Project	<b>IEEE 802.16 Broadband Wireless Access Working Group</b> < <a href="http://ieee802.org/16">http://ieee802.org/16</a> >	
Title	<b>Attachment relating to comments on document 802.16ab-01/01r2</b>	
Date Submitted	<b>2001-10-18</b>	
Source(s)	Yigal Leiba Yossi Segal Itzik Kitroser Dr. Zion Hadad Moshe Levinson  Runcom Technologies LTD. 2 Ahoma St. 75655, Rishon Lezion Israel	Voice: 972-3-9528440 Fax: 972-3-9528805 <a href="mailto:yigall@runcom.co.il">yigall@runcom.co.il</a> <a href="mailto:yossis@runcom.co.il">yossis@runcom.co.il</a> <a href="mailto:itzikk@runcom.co.il">itzikk@runcom.co.il</a> <a href="mailto:zionh@runcom.co.il">zionh@runcom.co.il</a> <a href="mailto:moshel@runcom.co.il">moshel@runcom.co.il</a>
Re:	Working group review, document IEEE 802.16-01/49	
Abstract	The document contains text and drawings that relate to comments submitted on document P802.16ab-01/01r2	
Purpose	For insertion into document P802.16ab-01/01r2

New section to add to the OFDMA MAC section:

### 6.2.7.10.1.3 OFDMA data mapping

Figure 1: OFDMA data mapping

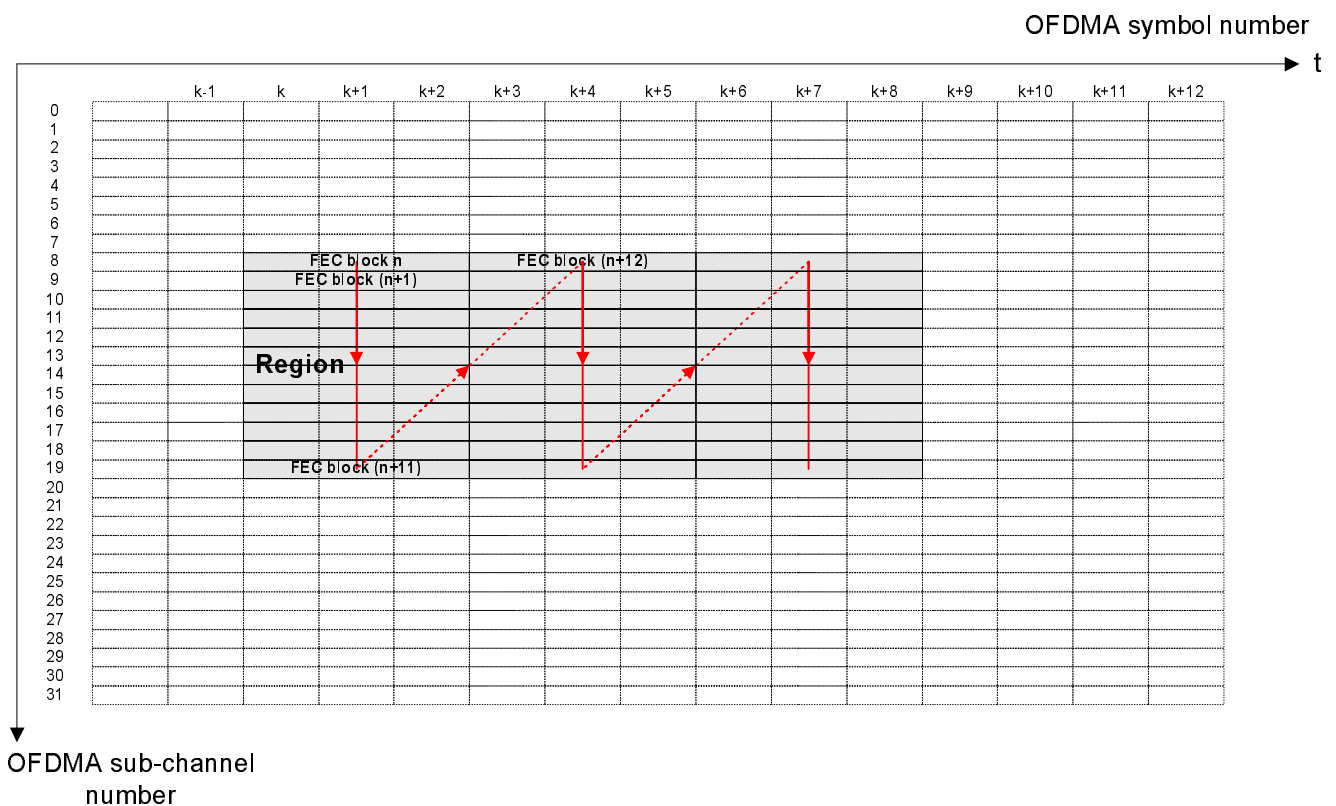
MAC data shall be mapped to an OFDMA **Region** (see 6.2.7.10.1.2) using the following algorithm:

1. Segment the data into blocks sized to fit into one FEC block.
2. Each FEC block spans one OFDMA sub-channel in the sub-channel axis and three OFDMA symbols in the time axis (see figure 153). Map the FEC blocks such that the lowest numbered FEC block occupies the lowest numbered sub-channel in the lowest numbered OFDMA symbol.
3. Continue the mapping such that the OFDMA sub-channel index is increased for each FEC block mapped. When the edge of the **Region** is reached, continue the mapping from the lowest numbered OFDMA sub-channel in the next OFDMA symbol.

Figure 2 below illustrates the order in which FEC blocks are mapped to OFDMA sub-channels and OFDMA symbols.
